# Access Compliance Report

## Public Rights-of-Way

### (Curb Ramps)

Intersection ID: 15195	Main Street: ALBEMARLE_RD	Cross Street: FARM_POND_LN	Location: NE
ADA ID: 140790009047	Ramp Type: Perp	Initial Pass/Fail: Fail	Overall Compliance: No
Severity Score: 26.25			
Codes/Mitigation Info/Possible Solution		Field Measurements/Component Compliance

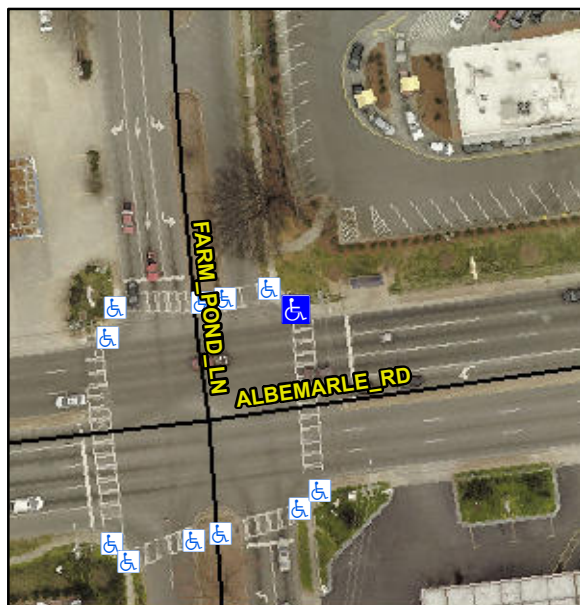
**Not Found, R304.2.2**

Compliance	Description	Data	Compliance	Description	Data
N/A	Ramp Length (in)	57.0	No	Ramp Slope (%)	13.7
Yes	Ramp Width (in)	48.0	Yes	Ramp XSlope (%)	3.3
N/A	Flare Type LT	N/A	N/A	Flare Type RT	N/A
N/A	Flare Slope LT (%)	N/A	N/A	Flare Slope RT (%)	N/A
N/A	Flare Traversable LT?	N/A	N/A	Flare Traversable RT?	N/A
N/A	Landing Length (in)	N/A	N/A	DWS Provided?	N/A
N/A	Landing Width (in)	N/A	N/A	DWS Contrast?	N/A
N/A	Landing Slope (%)	N/A	N/A	DWS Length (in)	N/A
N/A	Landing X Slope (%)	N/A	N/A	DWS Full Width?	N/A
N/A	Landing Curb? (Y/N)	N/A	N/A	DWS Offset (in)	N/A
N/A	Shared Landing?	N/A			
N/A	Gutter Ponding?	Yes	N/A	Gutter Slope (%)	N/A
N/A	Gutter Lip Ht (in)	N/A	N/A	Gutter X Slope (%)	N/A
N/A	Painted X Walk1?	Yes	N/A	Painted X Walk2?	N/A
	X Walk 1 Direction	To S		X Walk 2 Direction	N/A
N/A	X Walk 1 Width (in)	110.0	N/A	X Walk 2 Width (in)	N/A
	X Walk 1 Slope (%)	2.7		X Walk 2 Slope (%)	N/A
	X Walk 1 X Slope (%)	5.1		X Walk 2 X Slope (%)	N/A

**Remove & Replace Entire Ramp.**
